(Your Ref: MP10\_0177 MOD 4)

**RE: COUNCIL SUBMISSION TO MP10\_0177 MOD 4, APPLICATION FOR MODIFICATION  
OF MAJOR PROJECT APPROVAL UNDER SECTION 75W**

**PROPOSED CONCEPT PLAN OF  
SLIP LANE-S94-WORK ITEM NO-7**

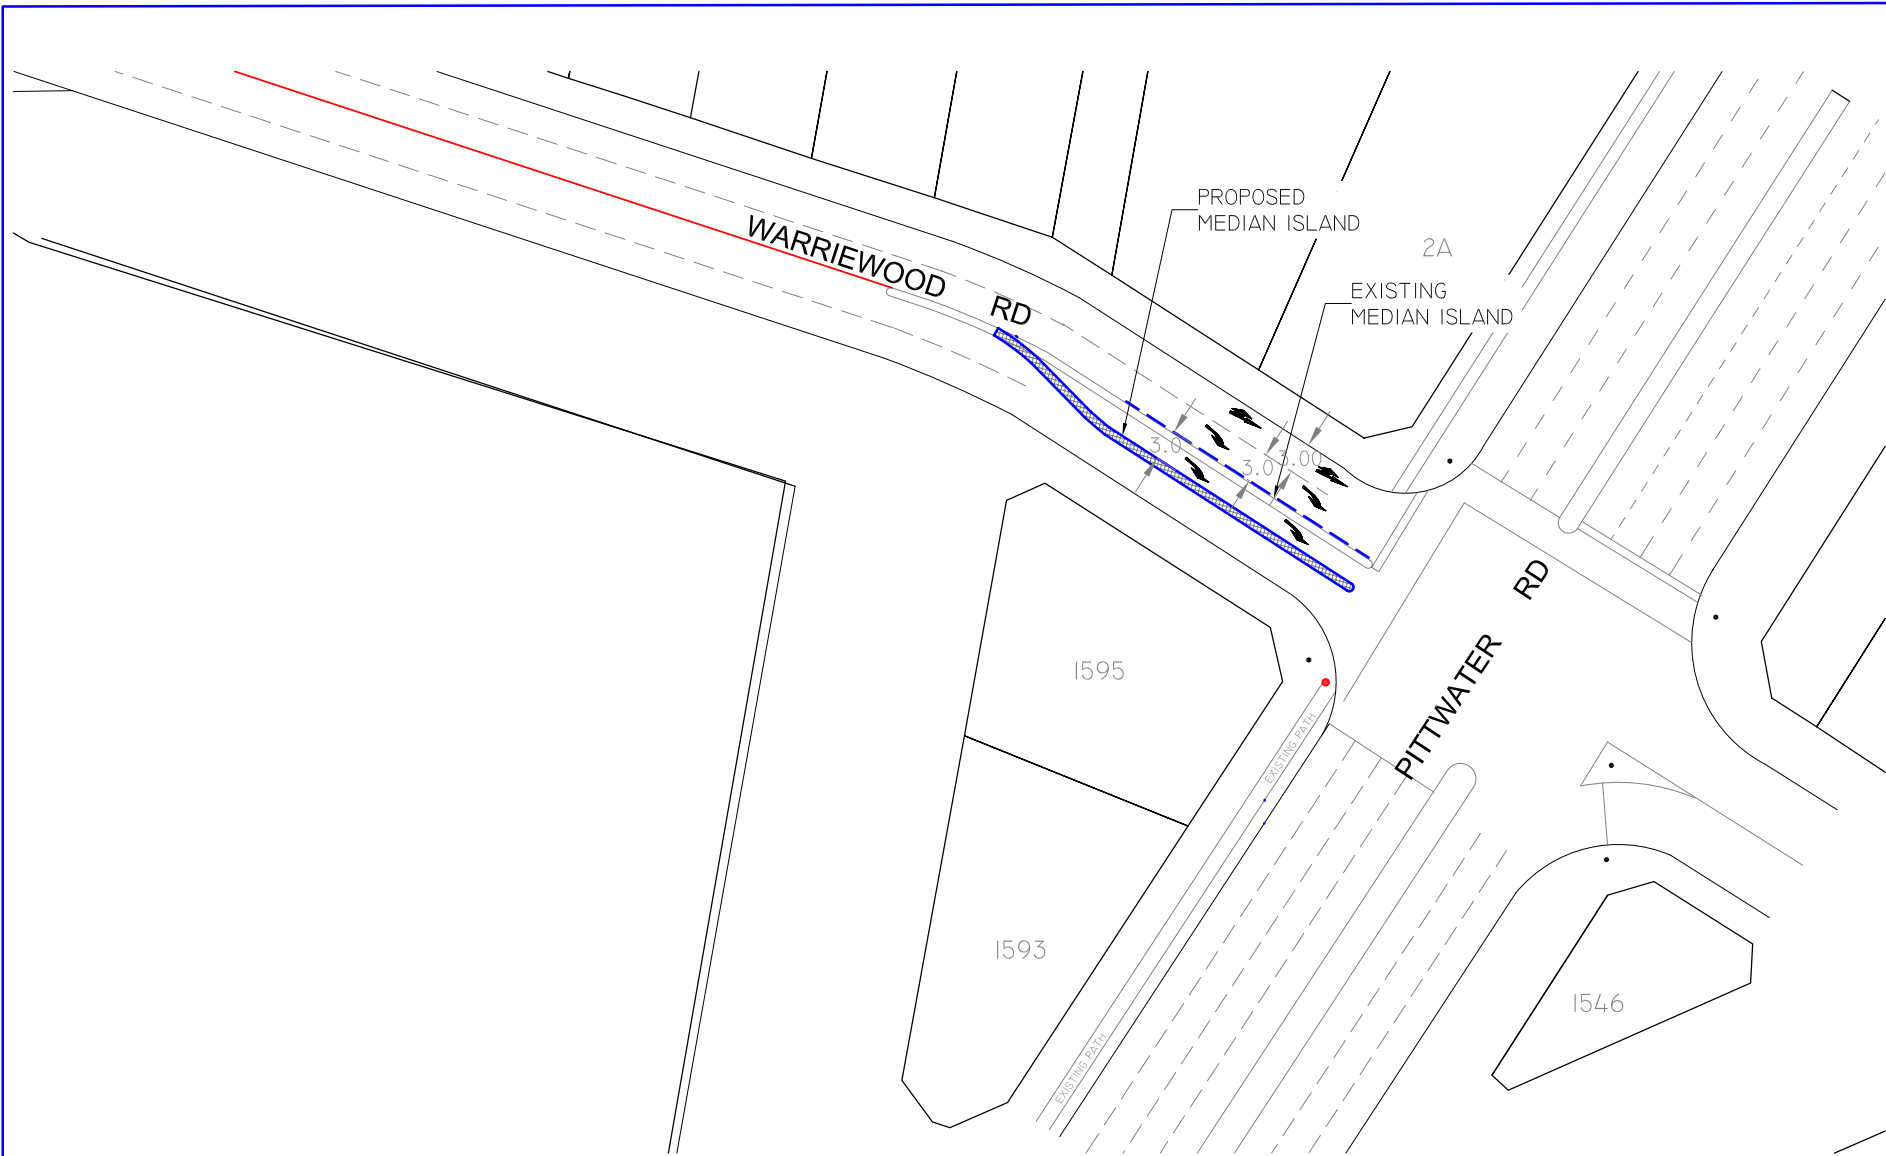
- (b) The RMS incorrectly identified \$139,412.10 for intersection upgrades at Pittwater Road and Warriewood Road. The works item estimated at \$139,412.10 are for works within Warriewood Road (one of the entrances into the land release). The works in Warriewood

Road seeks to improve access into Pittwater Road at this intersection (A copy of the design plans is provided for your information).

The item in the Section 94 Plan does not relate to the right turn lane extension in Pittwater Road as required by Condition F15.
